## ADDENDUM

No. 01 Date: 8/29/2024  
Project No. 0020711.01 Attention: Leonard D'Souza  
Project Name: Princess Margaret Cancer Centre  
Stem Cell Transplant 2, MHC, MHDU, DSC  
Address: University Health Network  
610 University Avenue  
Toronto ON

*This Addendum forms a part of the Bidding and Contract Documents and modifies the original issued Bidding Documents (dated August 13, 2024) for the above titled project, as indicated below, and is hereby incorporated into the Contract Documents as part thereof.*

**A1105B**

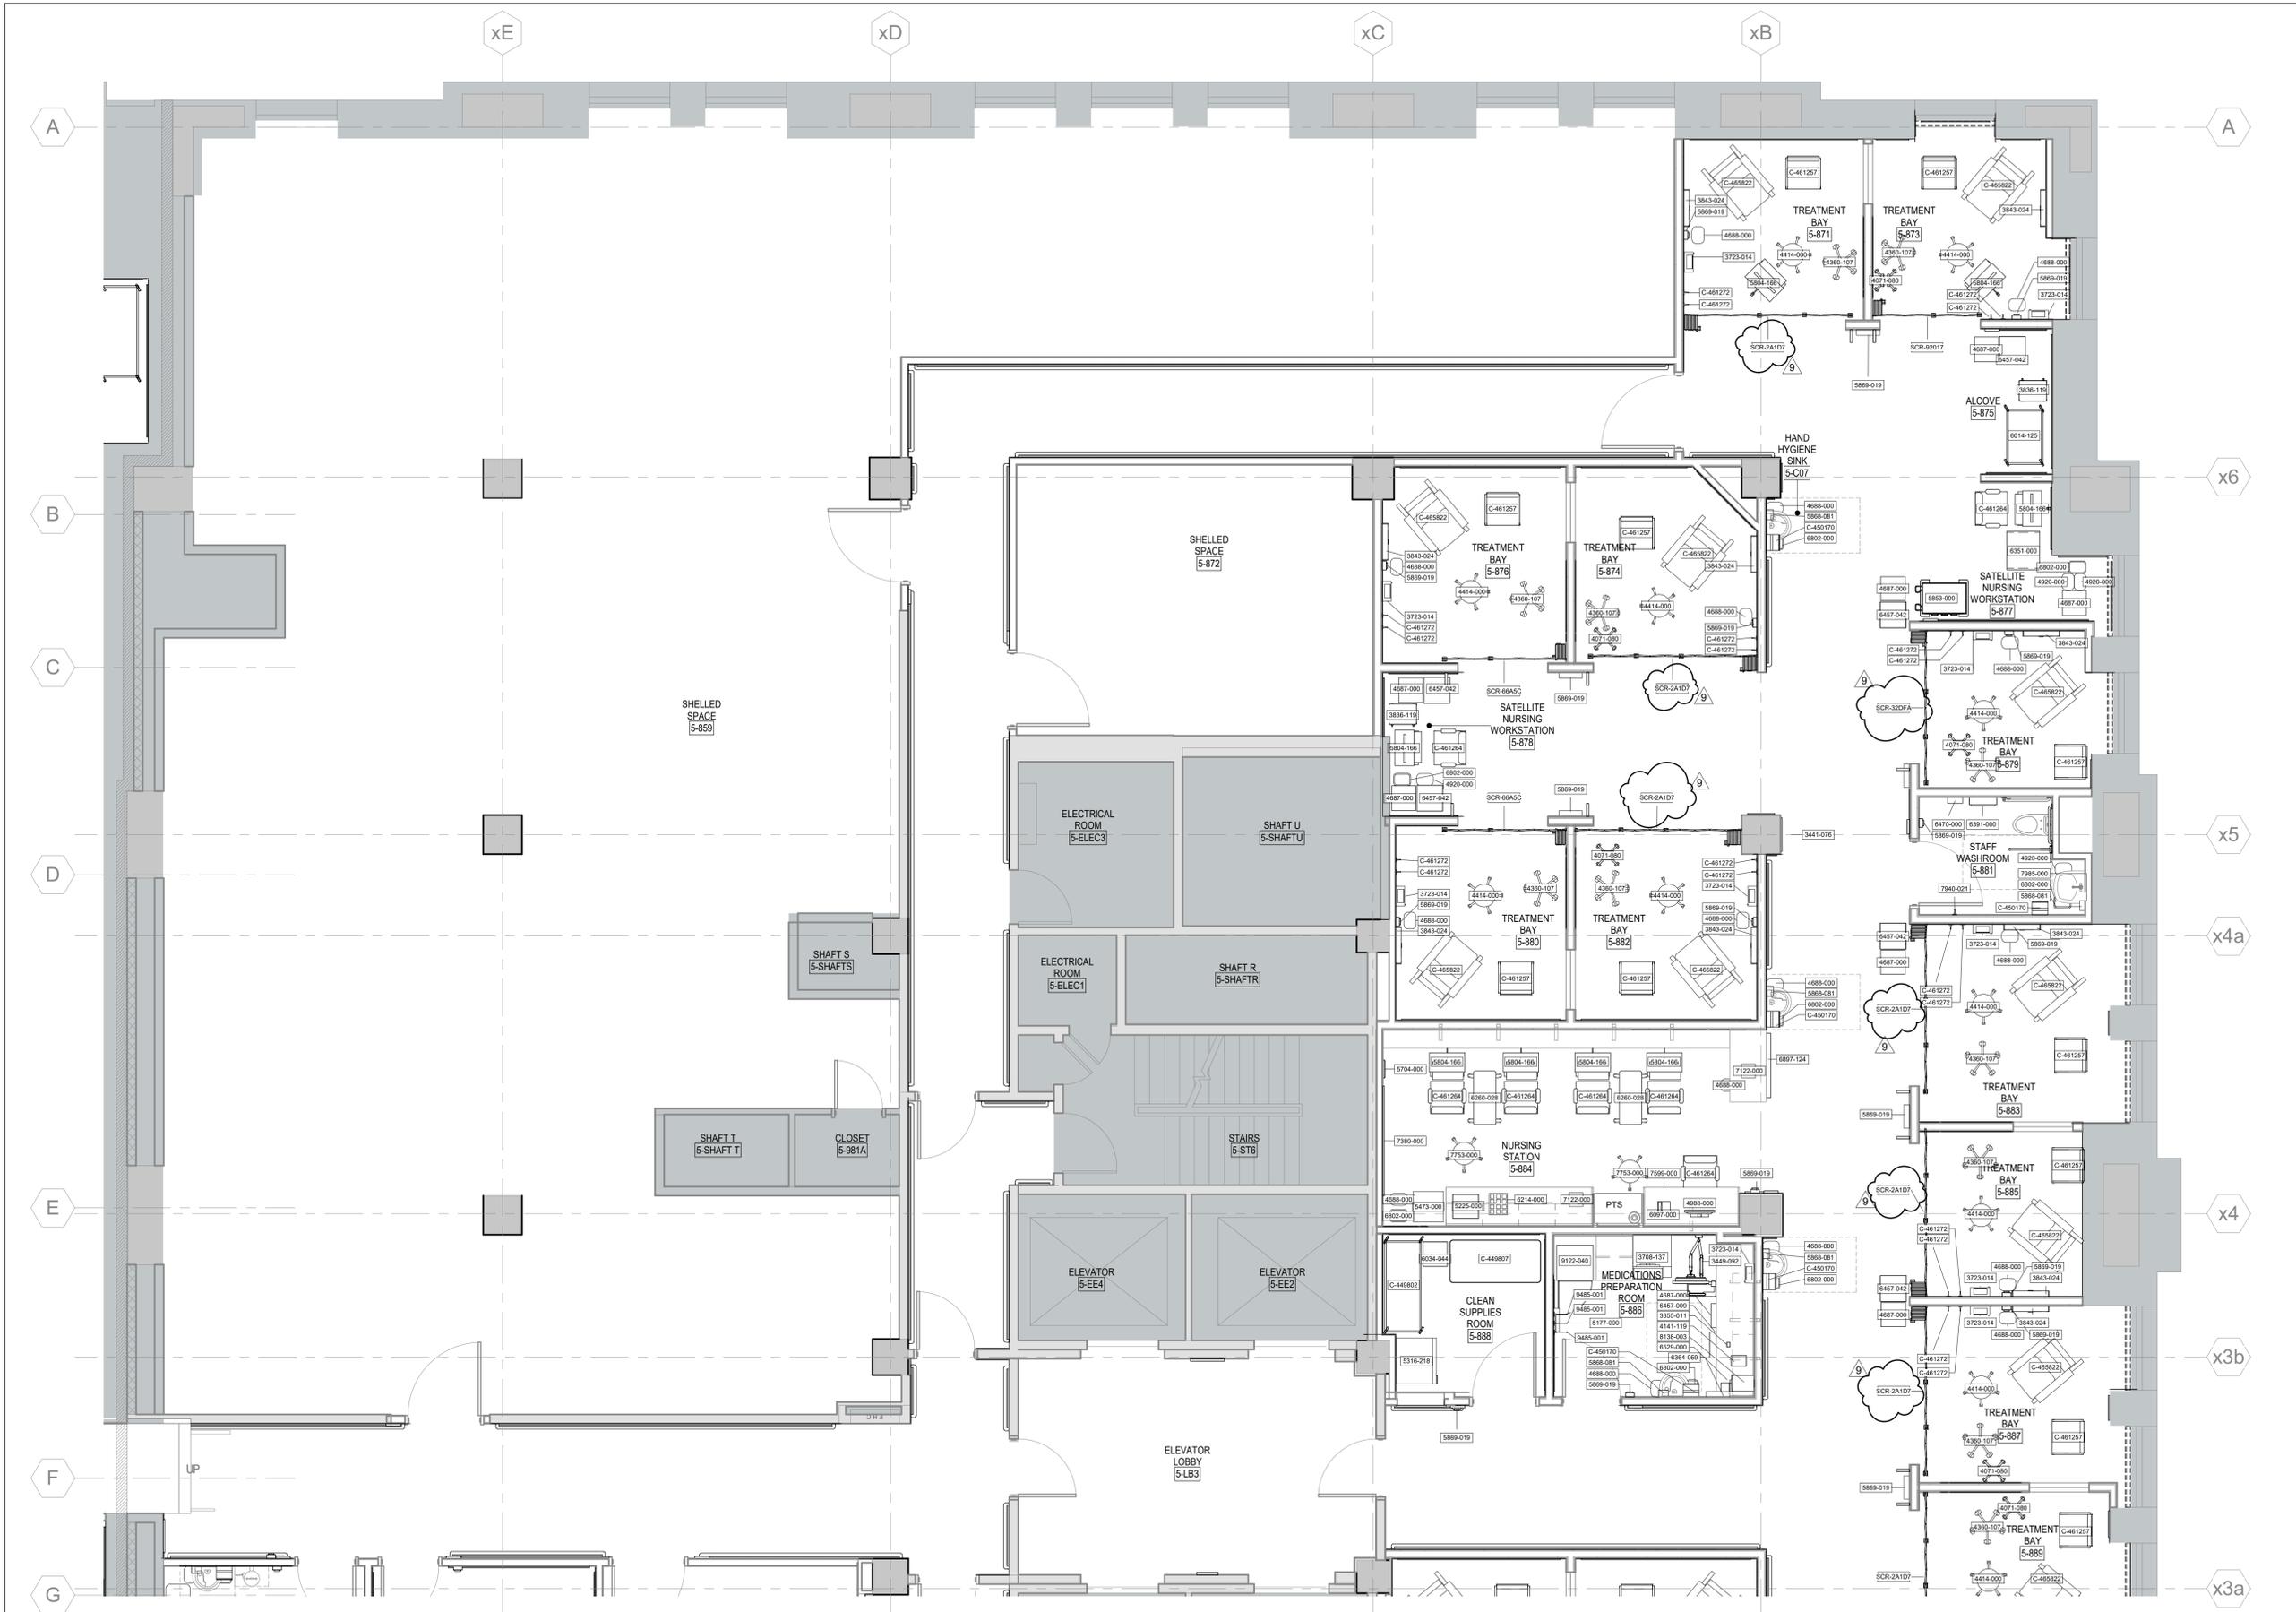
**5. A1105B - EQUIPMENT PLAN - LEVEL 5E (MHDU)**

Privacy Screen Tags updated.

**EQUIPMENT PLAN -  
LEVEL 5D (MHDU)**

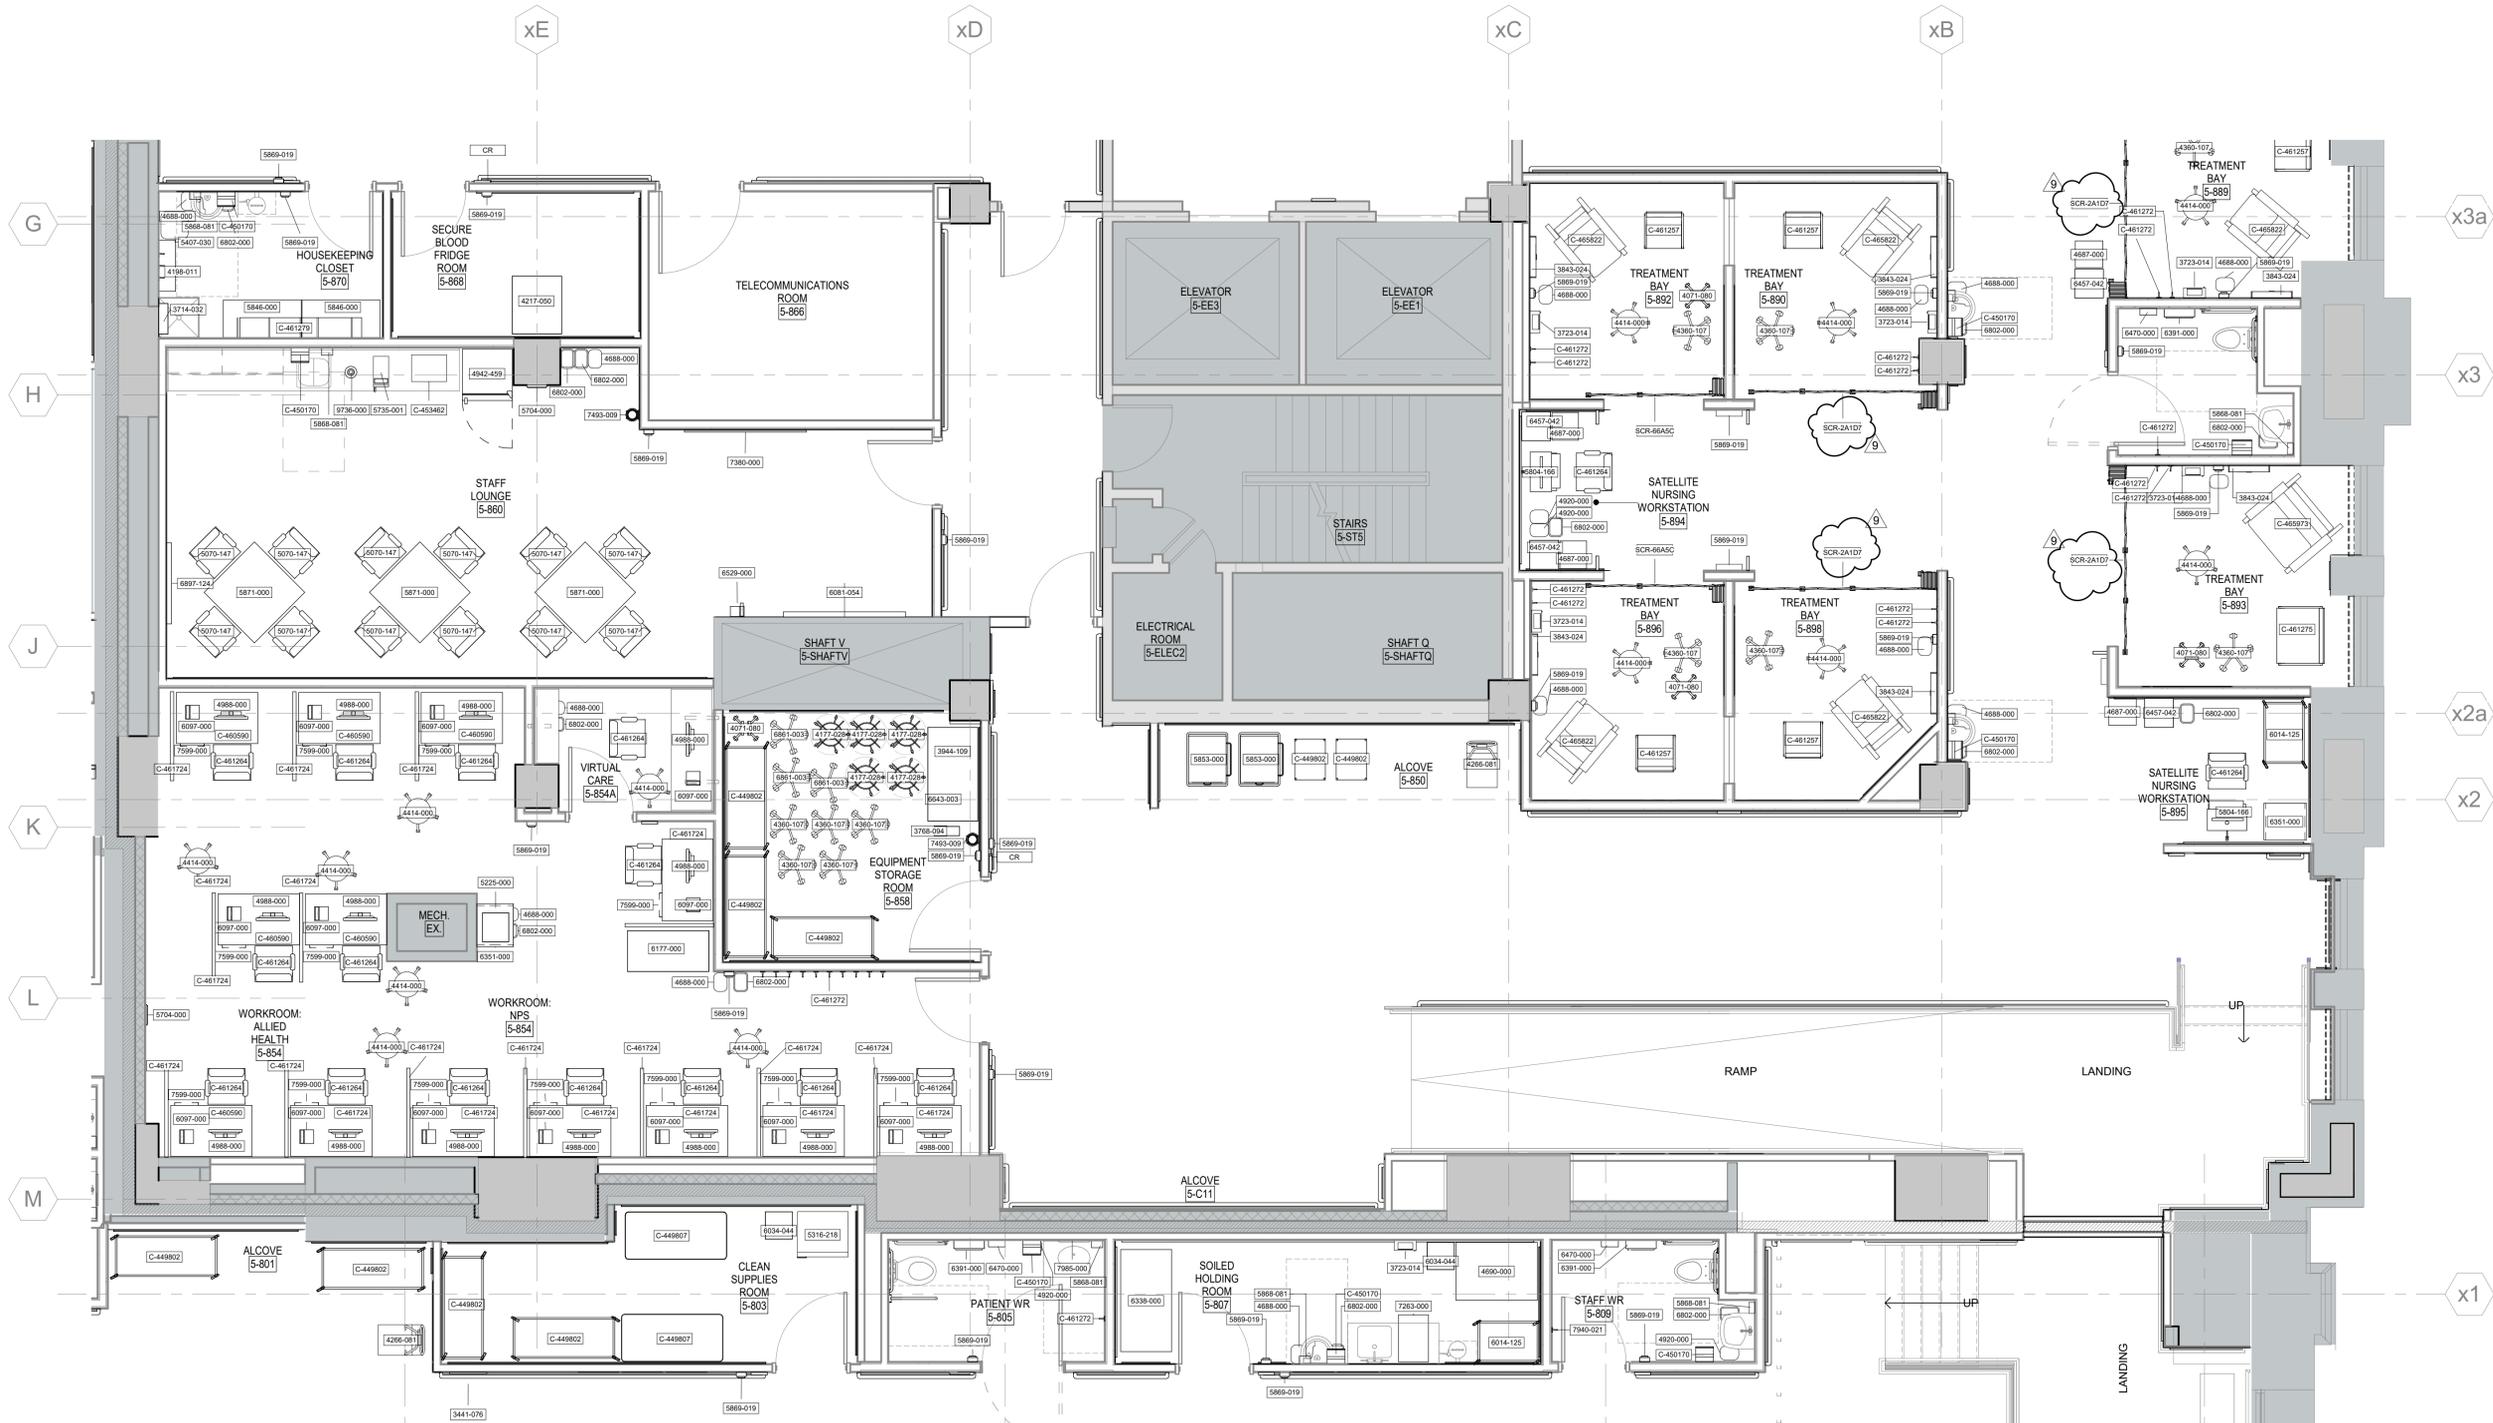
**6. A1105D - EQUIPMENT PLAN - LEVEL 5E (MHDU)**

Privacy Screen Tags updated.

**EQUIPMENT PLAN -  
LEVEL 5E (MHDU)**

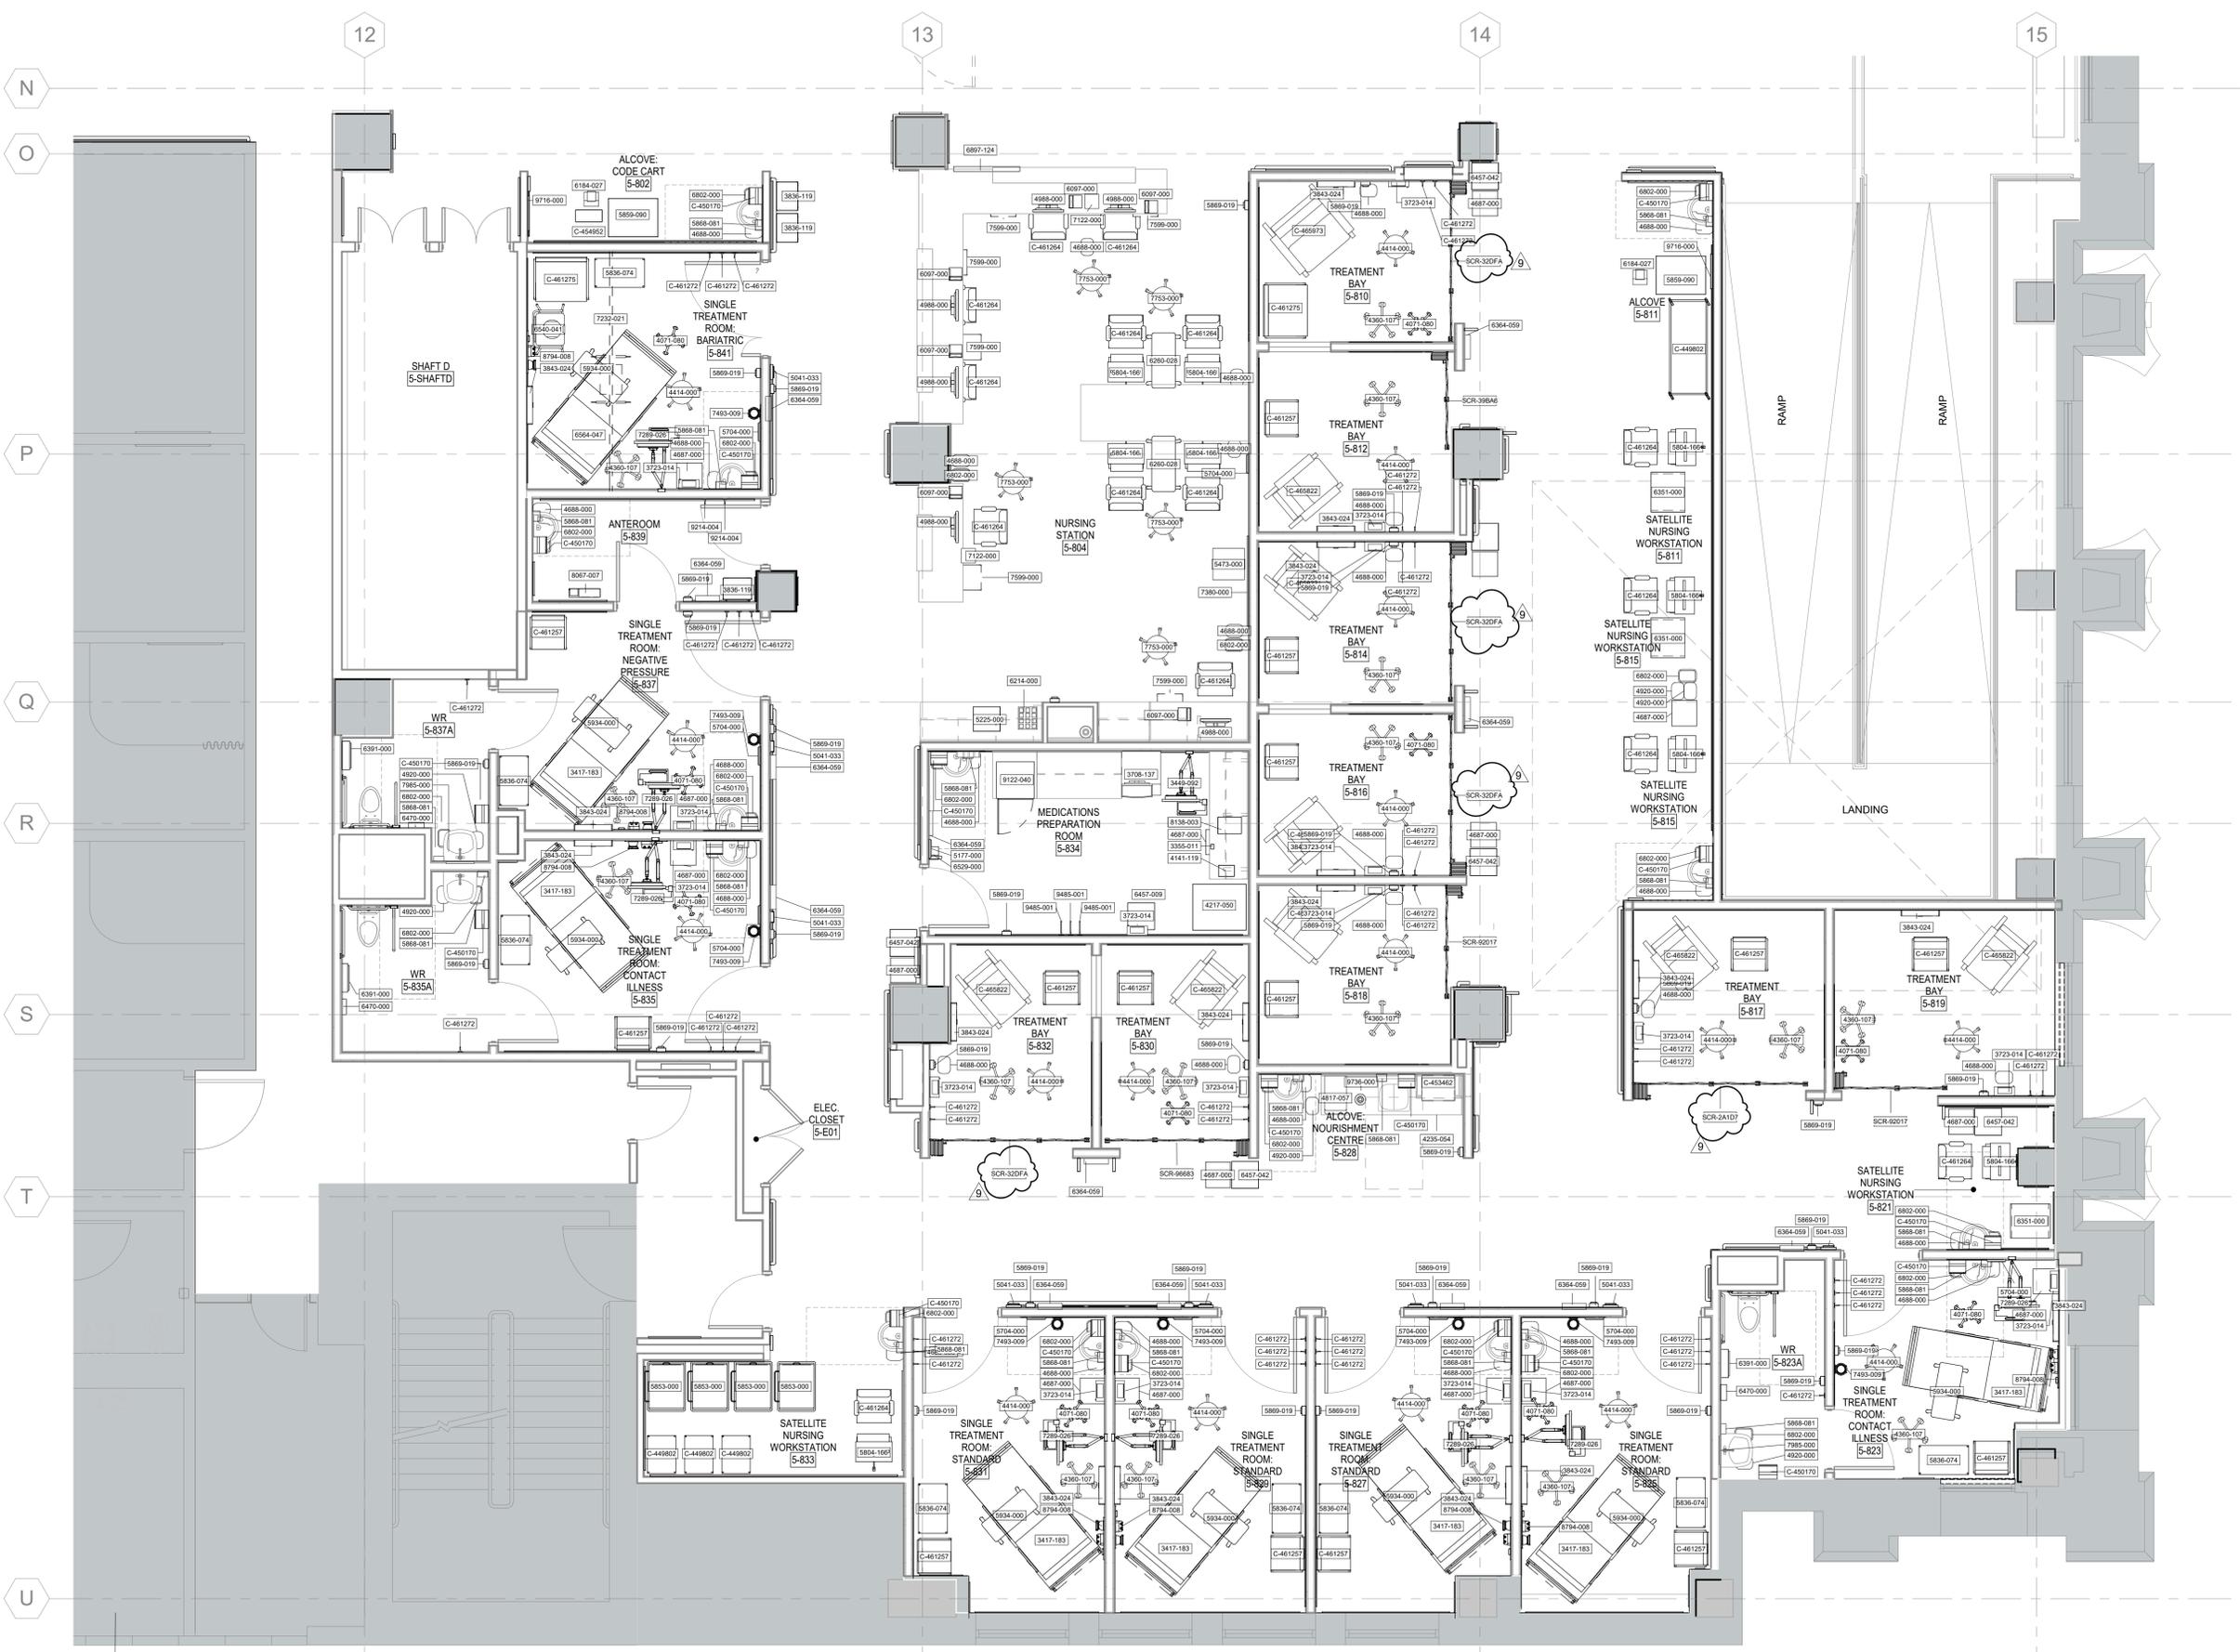
**7. A1105E - EQUIPMENT PLAN - LEVEL 5E (MHDU)**

Privacy Screen Tags updated.
